# Town of Leicester PLANNING BOARD

## PLANNING BOARD AGENDA WEDNESDAY September 22, 2021 @ 7:00PM

## Memorandum

**TO:** Planning Board Members  
**FROM:** Michelle R. Buck, AICP  
Town Planner/Director of Inspectional Services  
**DATE:** September 2, 2021  
**RE:** **September 7, 2021 Planning Board Meeting**

WATER QUALITY SWALE, SUBDRAIN, & UTILITY TRENCH DETAIL  
N.T.S.

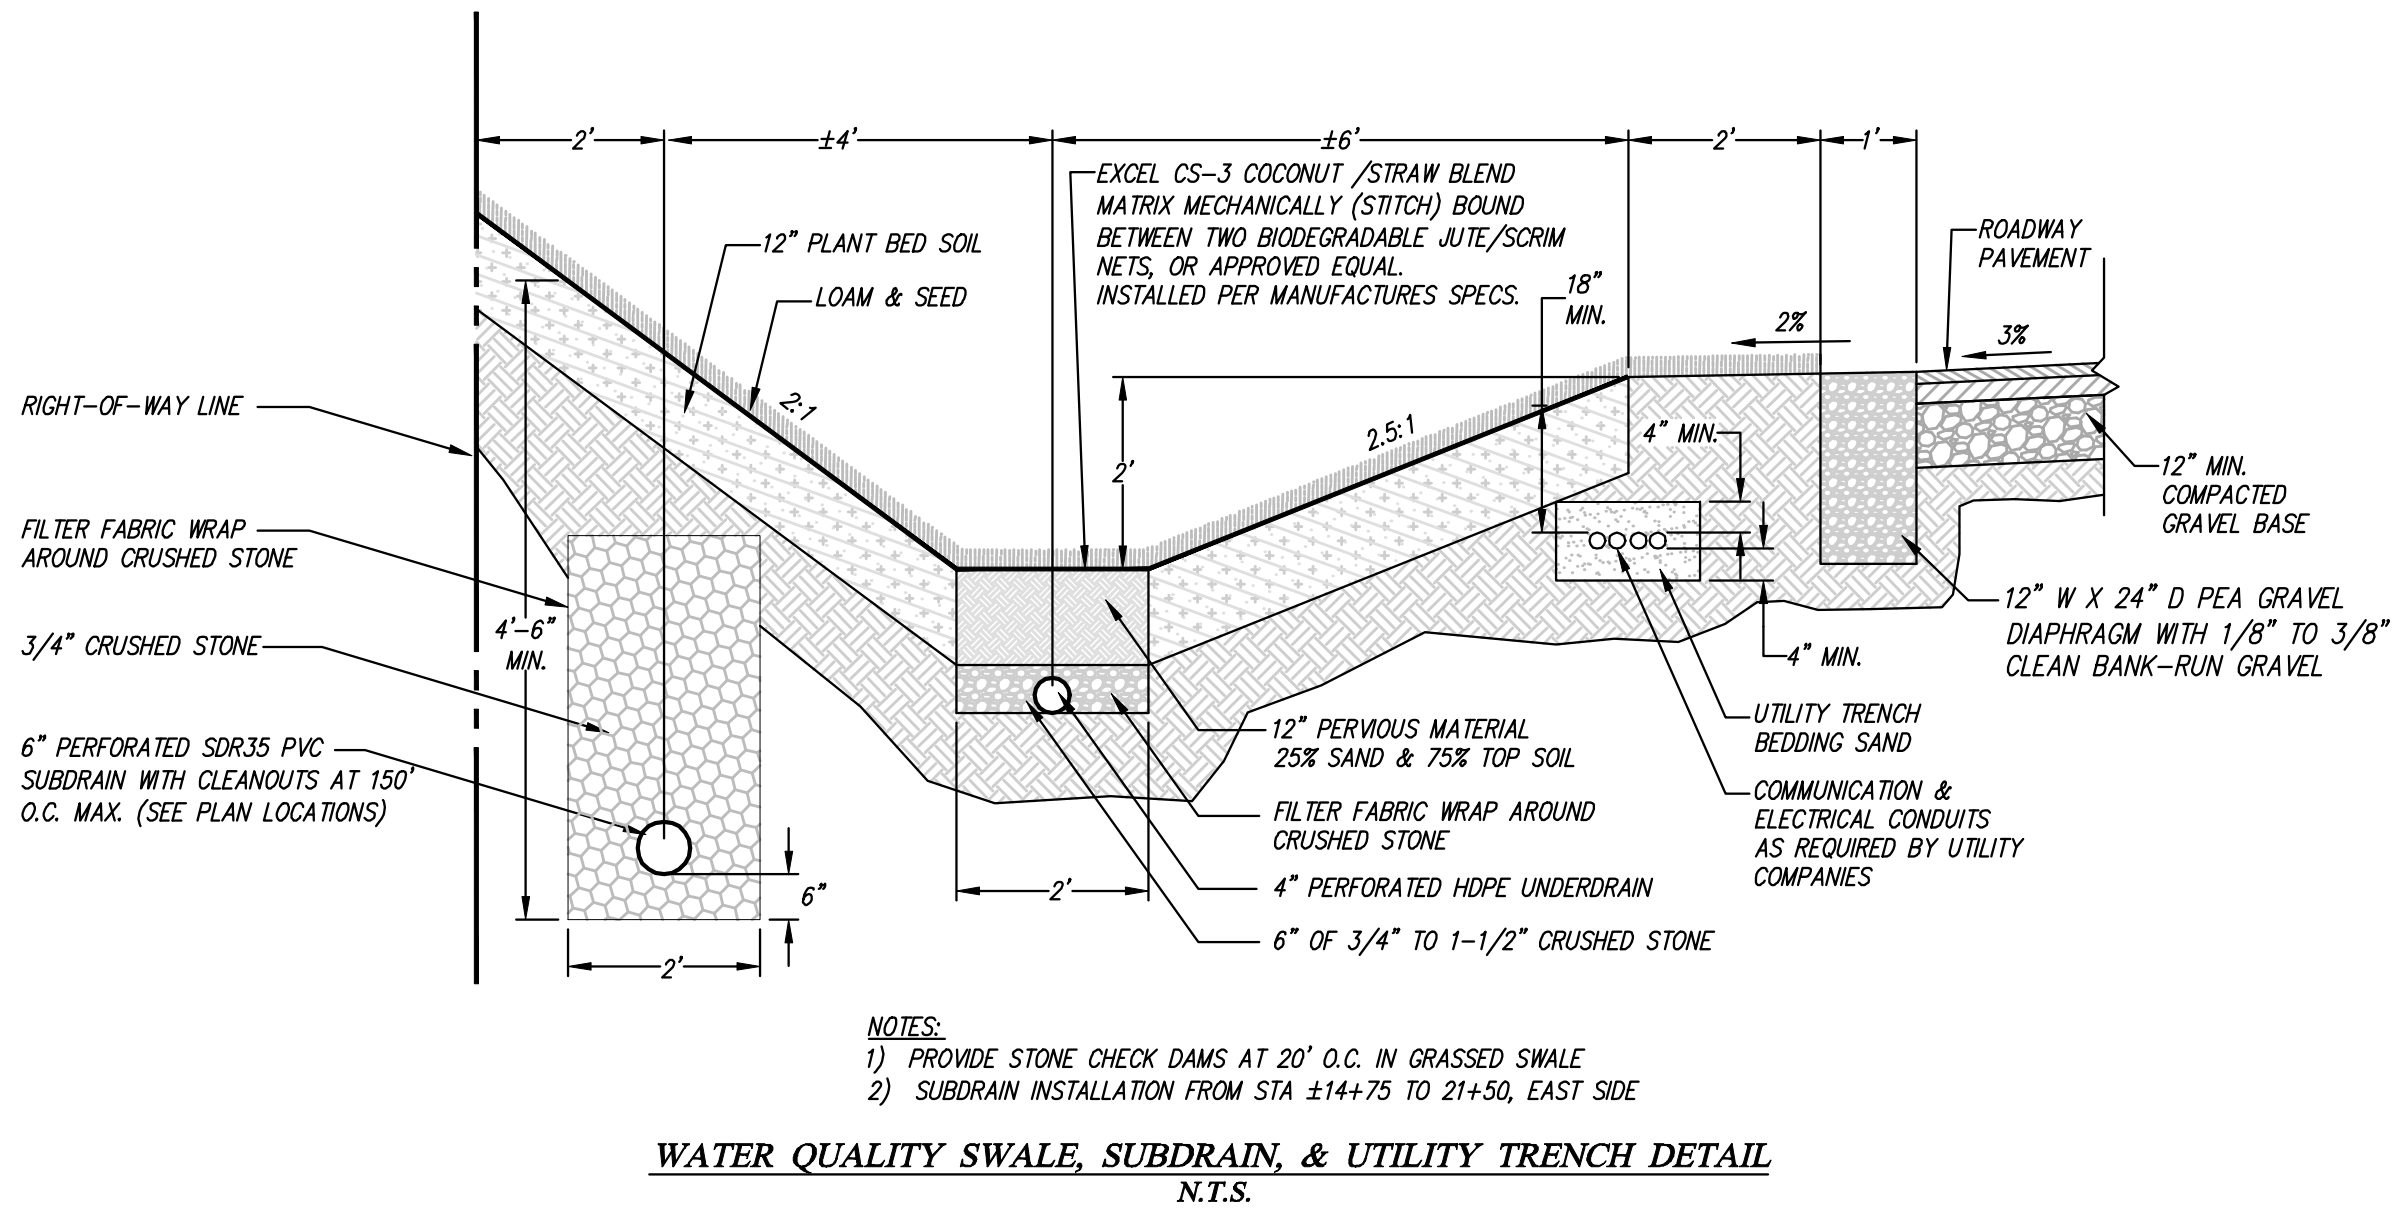
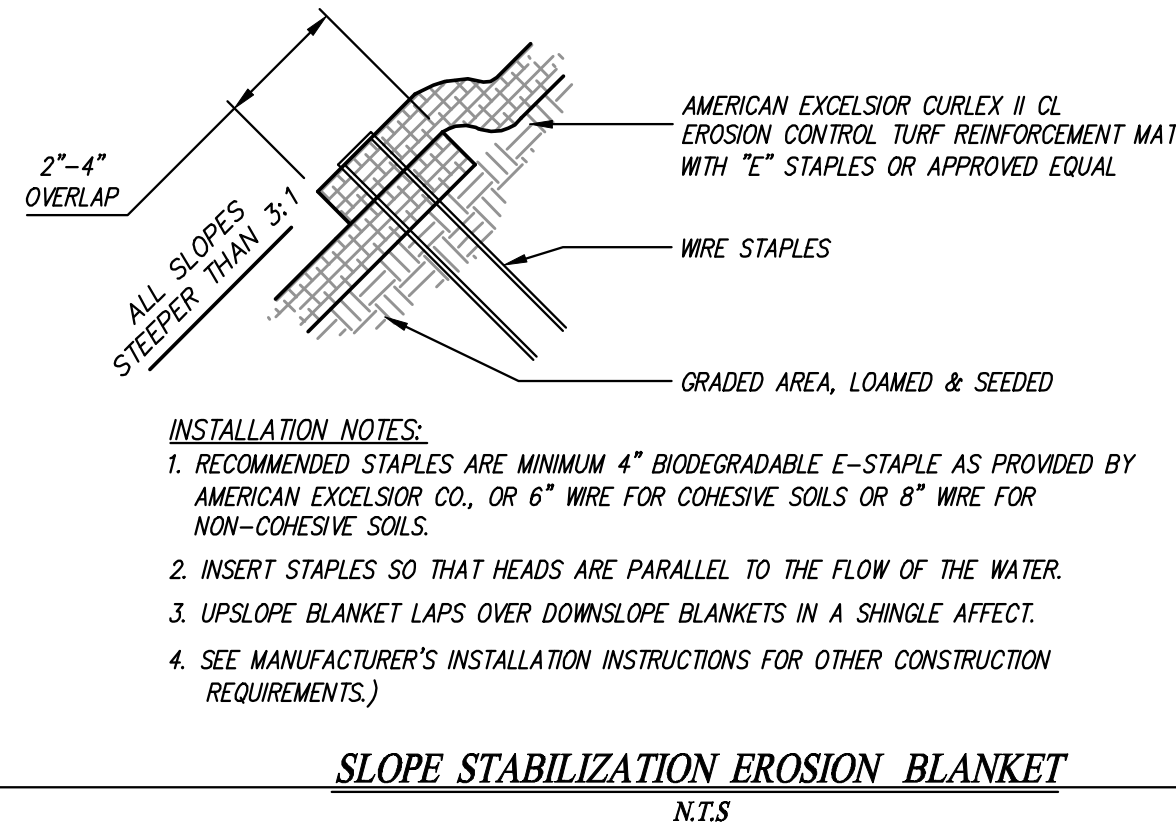
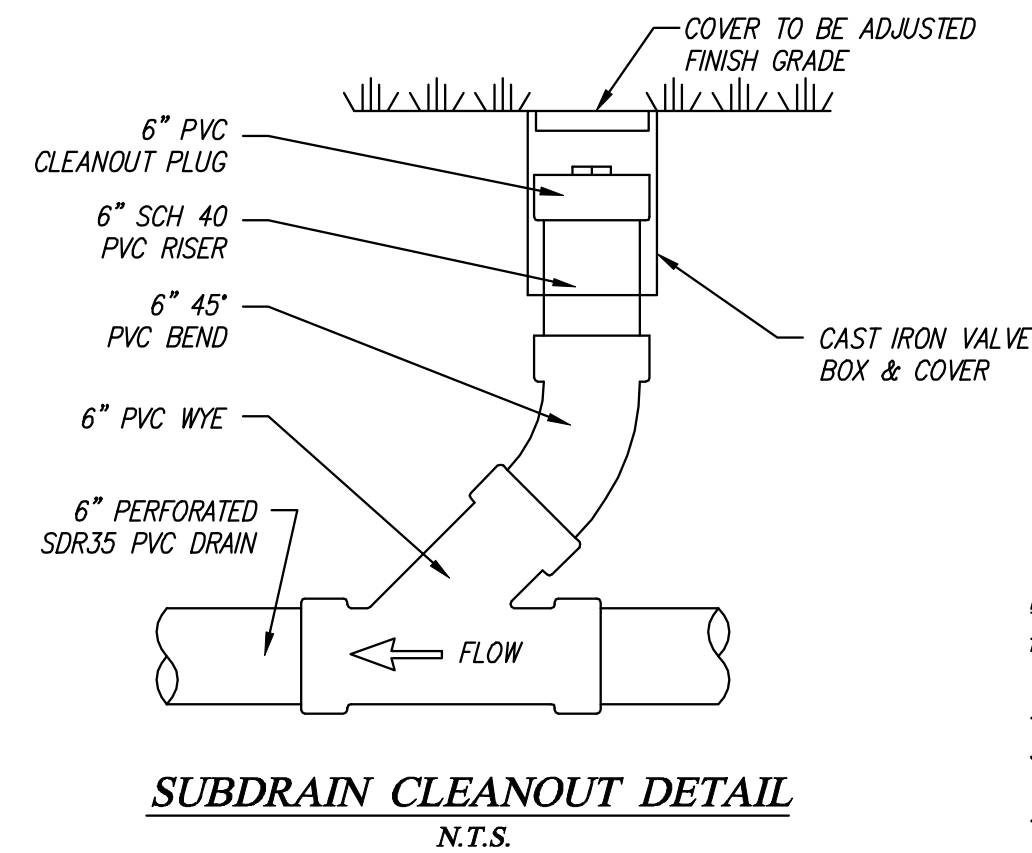
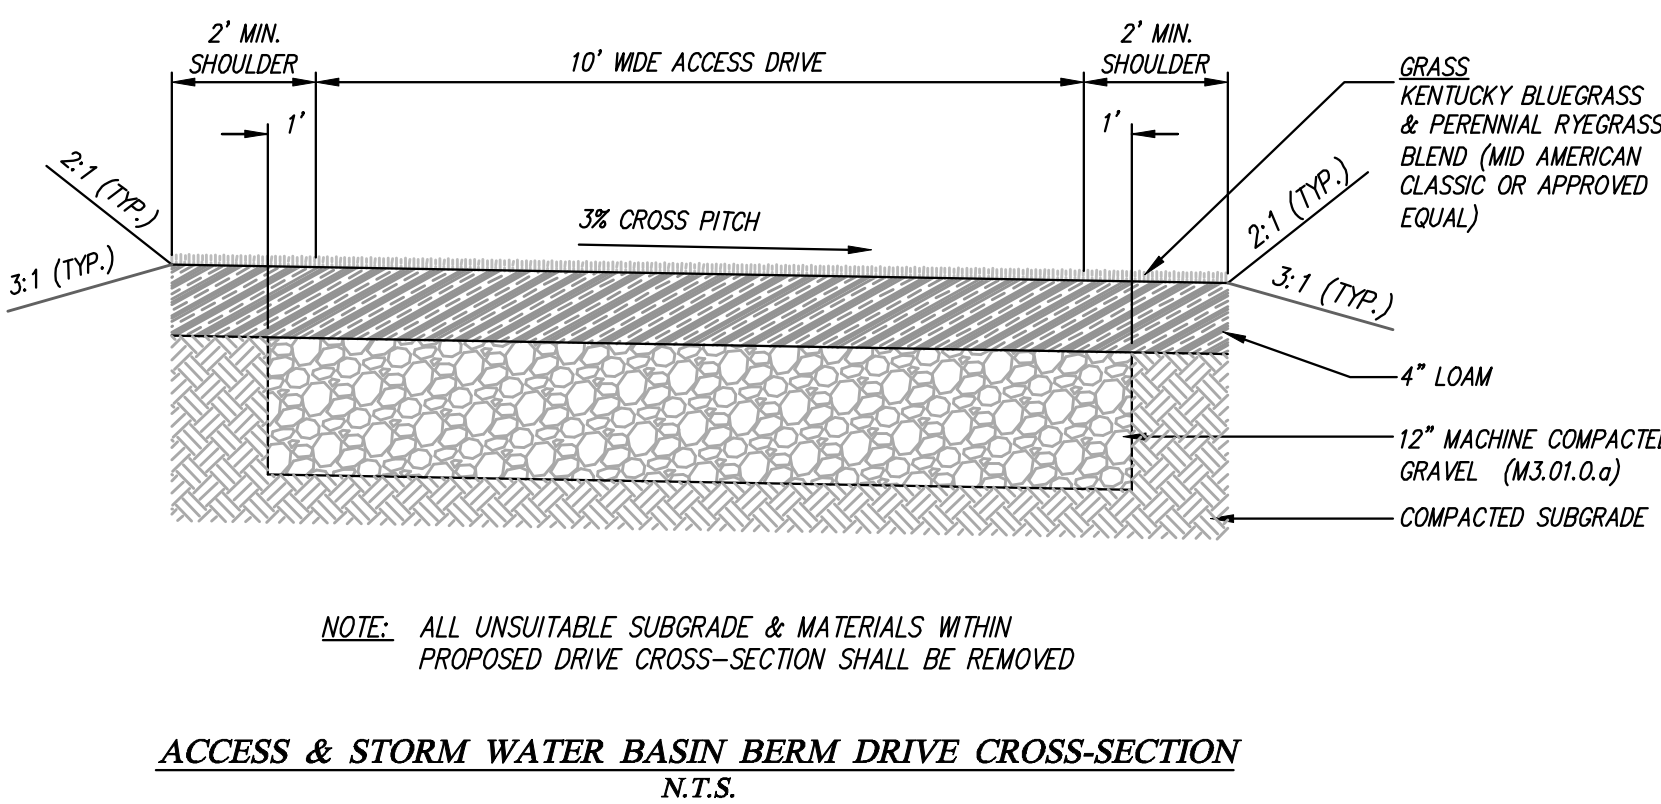
- 7. Sheet 7: Added additional construction details related to the water quality swale, level spreader diaphragm, subdrain & cleanouts, utility trench, stone check dams, and slope stabilization locations and design elevations.**
- 8. Sheet 8: Removed construction details for subdrain & cleanouts and the slope stabilization. These details have been revised and moved to Sheet 7.**
